# UNITED STATES PATENT AND TRADEMARK OFFICE

APPLICATION NO.	FILING DATE	FIRST NAMED INVENTOR	ATTORNEY DOCKET NO.	CONFIRMATION NO.
10/814,086	03/31/2004	Heinrich Roder	130229-02	7307

**Office Action Summary**

## **DETAILED ACTION**

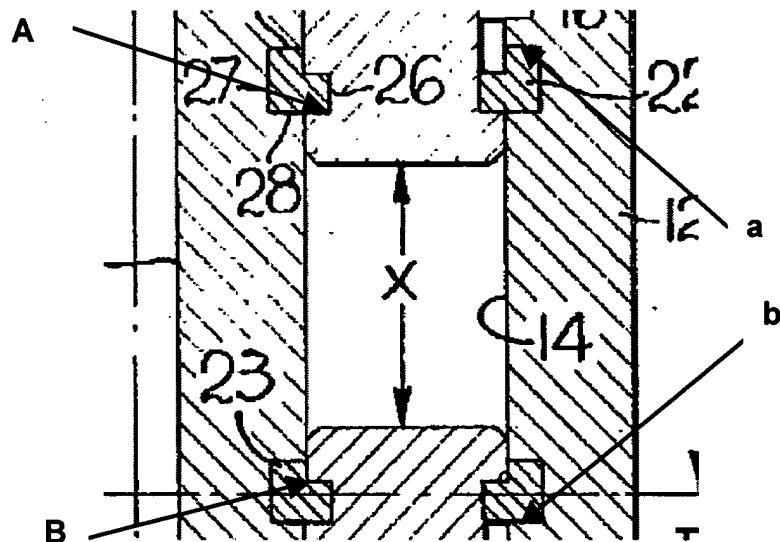
As to claim 1, Draut discloses a locking device capable of vertical connection of an upper connection component **18**, that comprises an upper engaging section, to a lower connection component **19**, that comprises a lower engaging section, the locking device comprising two shell segments **11,12** each of which only partially extends around opposite vertical sides of the connection from the outside and in a horizontal direction, with the shell segments comprising an upper and a lower edge **a,b** (upper and lower edges **a,b** are defined by annular grooves in shell segments **11,12**; Figure 1 reprinted below with annotations) at a respective axial end of the shell segment adjacent to each of which is provided an upper and a lower engaging section facing upper and lower engaging sections **23,A,23,B** of the upper and lower connection components so that, should the connection of the two connection components come apart, the upper engaging section of the shell segments is supported against the upper engaging sections **22,A** provided at the upper connection component, while the lower engaging

section of the shell segments holds the lower engaging sections **23,B** of the lower connection component (Figures 1-3).

Examiner disagrees. As to claim 1, Draut discloses a locking device comprising two shell segments **11,12** each comprising an upper and a lower edge **a,b** (upper and lower edges **a,b** are defined by annular grooves in shell segments **11,12**; Figure 1 reprinted below with annotations).
